SERVICE BULLETIN

No. 391

Piper Aircraft Corporation

Cargo Loading Instructions

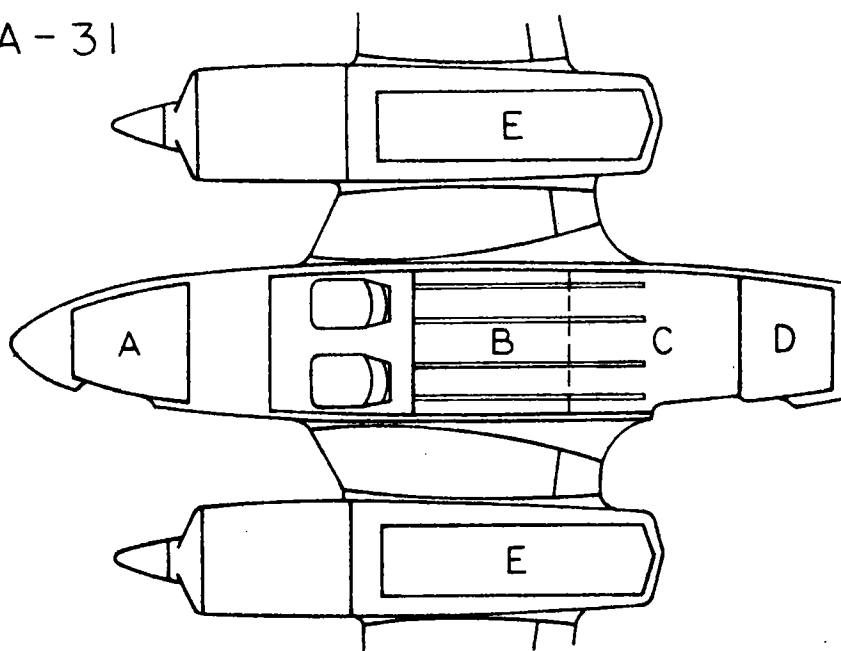
To provide cargo loading data relative to affected aircraft specified above, in accordance with the cargo loading placard data reproduced on the attached illustration.

1. Aircraft with cargo door only: check the cargo door (interior) upper trim panel to insure that the proper cargo loading placard (identical to the attached placard reproduction) is installed.

- a. If the placard is not installed or if the existing placard is not identical to the attached reproduction, refer to the attached cargo loading data placard reproduction until a new placard can be obtained and installed (reference Material Required, below).

- b. If the existing placard is identical to the attached reproduction, no further action is required.
2. Aircraft with cargo door and cargo interior furnishings option (cargo barrier, straps, tie-downs, etc.): comply with Instructions No. 1, above and check the aft baggage compartment upper rear panel to insure that the proper cargo loading placard (identical to the attached reproduction) is installed.

- c. In other words, for aircraft with both the cargo door and the cargo interior interior furnishings option installed, two (2) cargo loading placards (identical to the attached reproduction) are required, located as described above.

- a. Aircraft with cargo door only:
 1. Center placard on (interior) upper trim panel.
 2. Install placard using six (6) each MS20470-A3-3 black anodized rivets, Piper Code No. 420 192.
- b. Aircraft with cargo door and cargo interior furnishings option (cargo barrier, straps, tie-downs, etc.)
 1. Center placard on upper rear panel.
 2. Install placard using six (6) each MS20470-A3-3 black anodized rivets, Piper Code No. 420 192.

1. Cargo Loading Placard, Piper Part No. 53716-00 (582 082), either one (1) each or two(2) each required per aircraft, per Instructions 1 and 2, above.
2. Six (6) each MS20470-A3-3 black anodized rivets, Piper Code No. 420 192 per placard.
